In the Matter of)	
AMERGEN ENERGY COMPANY, LLC)	
(License Renewal for the Oyster Creek Nuclear Generating Station))	Docket No. 50-0219-LR

**PREFILED SUR-REBUTTAL WRITTEN TESTIMONY OF
DR. RUDOLF H. HAUSLER REGARDING
CITIZENS' DRYWELL CONTENTION**

Figure 1

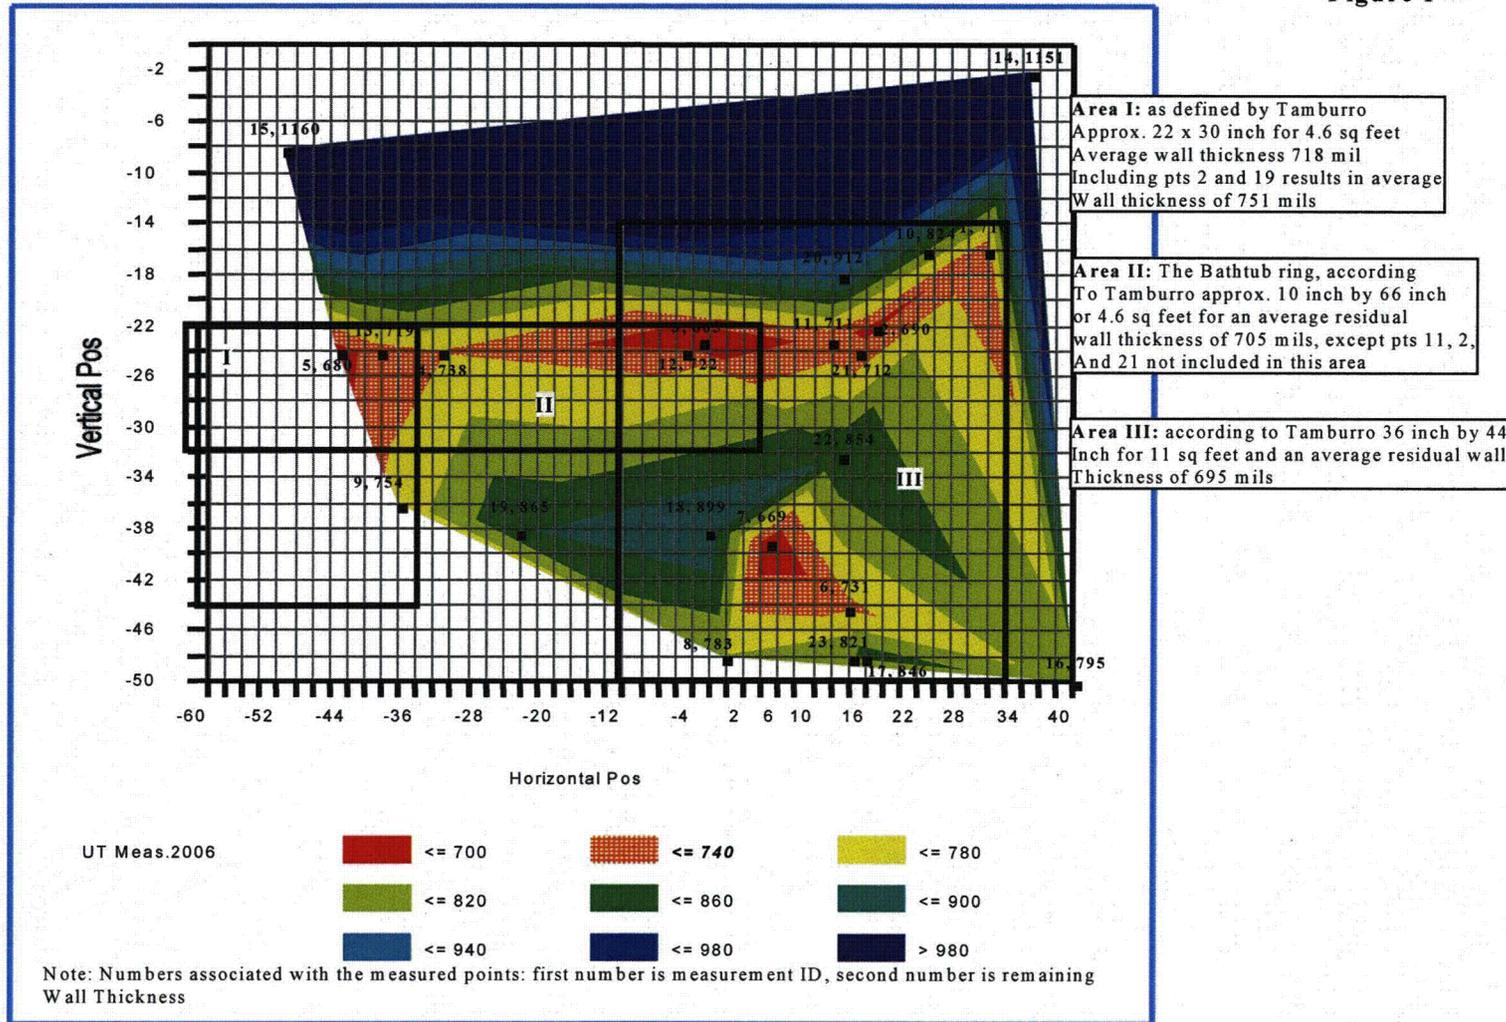
Bay 1 Contour Plot for 2006 External Measurement Data
 Individual Evaluation Areas from Tamburro Analysis superimposed [see Calc. 24 Rev. 2 Fig. 2-1]

Figure 2

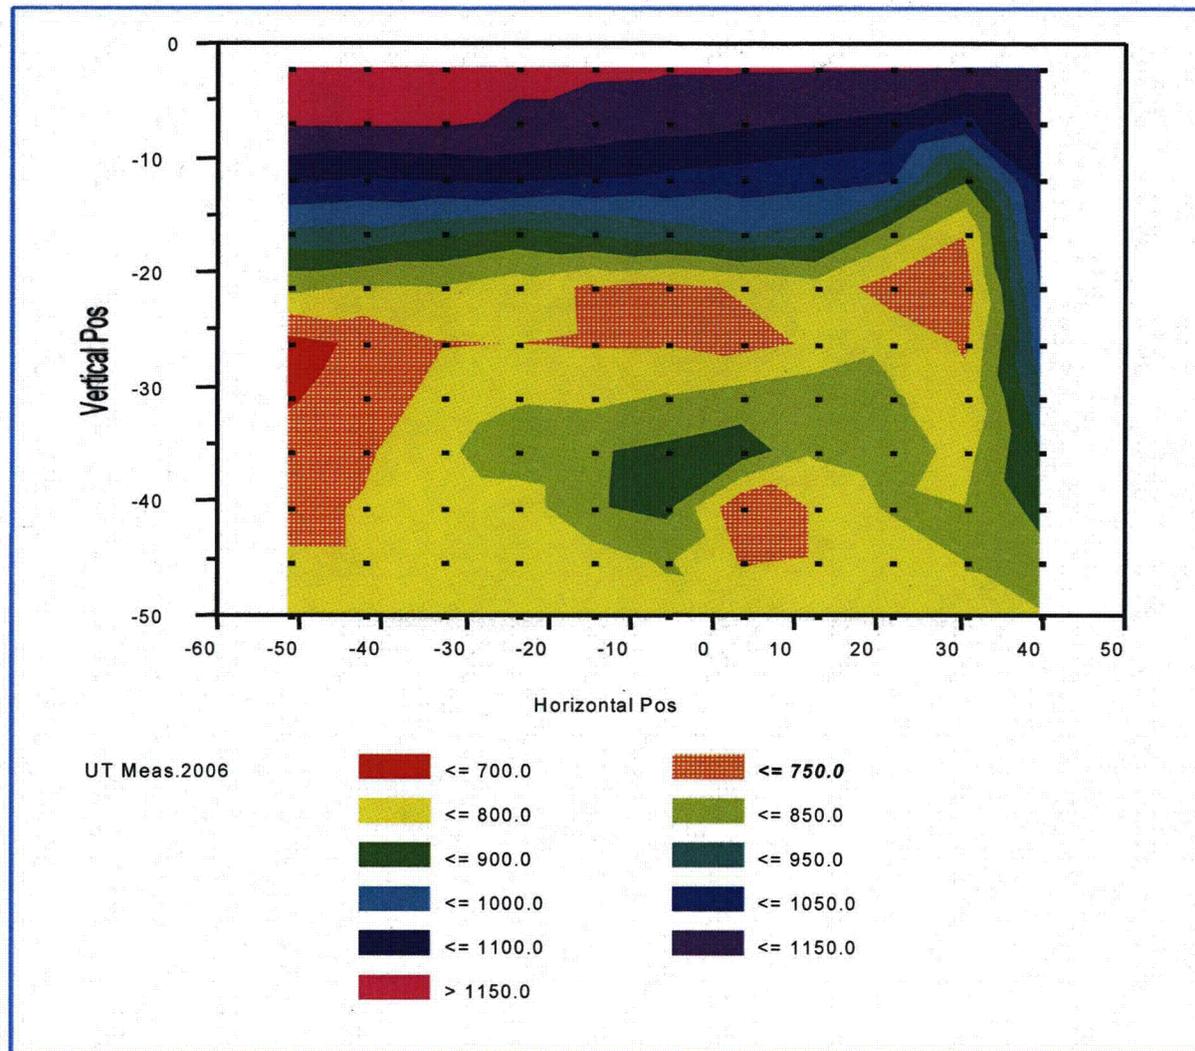
Bay 1 Predictive Response Surface Calculated from Triangulation
External UT Measurements 2006

Figure 3

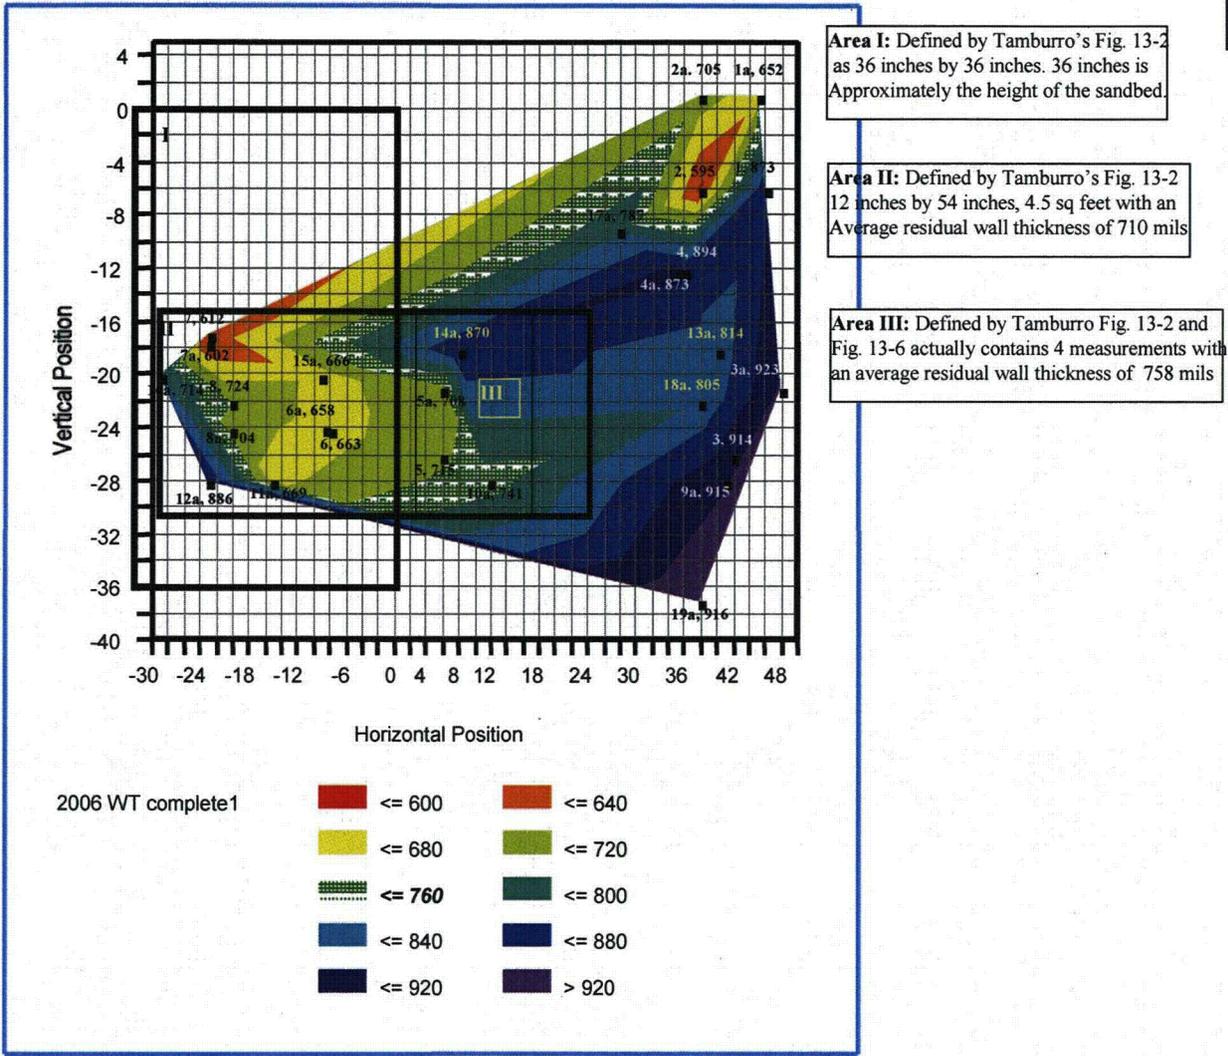
Contour Plot for External UT Measurements 2006

Figure 4

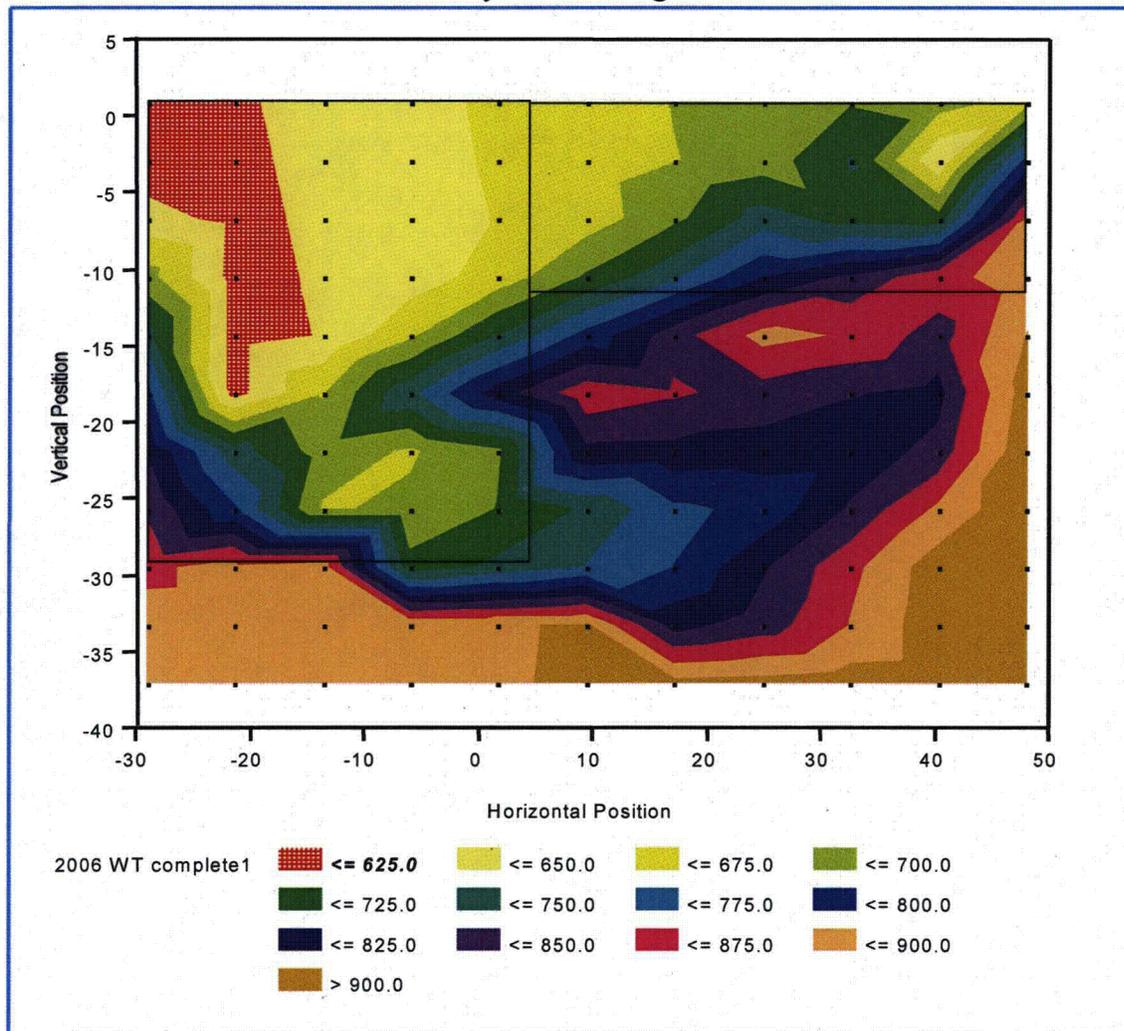
Predicted Response Surface for area of Bay 13
 Contiguous Areas which are less than 725 mils about 12 sqft
 Bordered by the dark green areas.

Figure 5

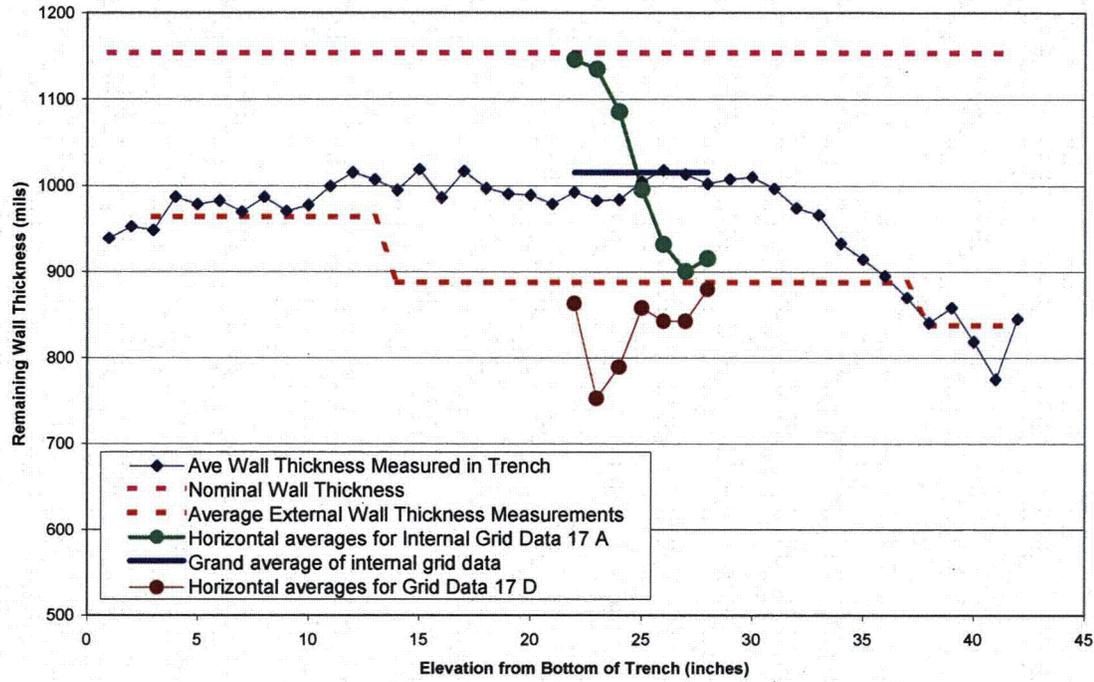
elevations (not what one would have expected) , 17 D on the other hand mirrors the corrosion observed in the trench, but only at lower elevation. We have now combined all data in Figure 5 of Citizens' Ex. 61 and hope that the elevation data as reported were in fact the correct ones. When looking at that figure, one must remember that the data are only plotted as a function of the vertical distance from the bottom of the sandbed, but no doubt the data are not in the same lateral positions. Rather than "our argument falling apart" (namely that "internal grid measurements do not reflect the true corrosion of the sand bed"), Figure 5 of the memorandum fully supports the notion that no single set of measurements fully represents the extent of corrosion in the sandbed. However, I also think that one needs to look first and foremost at the most serious corrosion damage, because there is the greatest danger of failure. This is often located below the 11'3" height where the internal grids are taken.
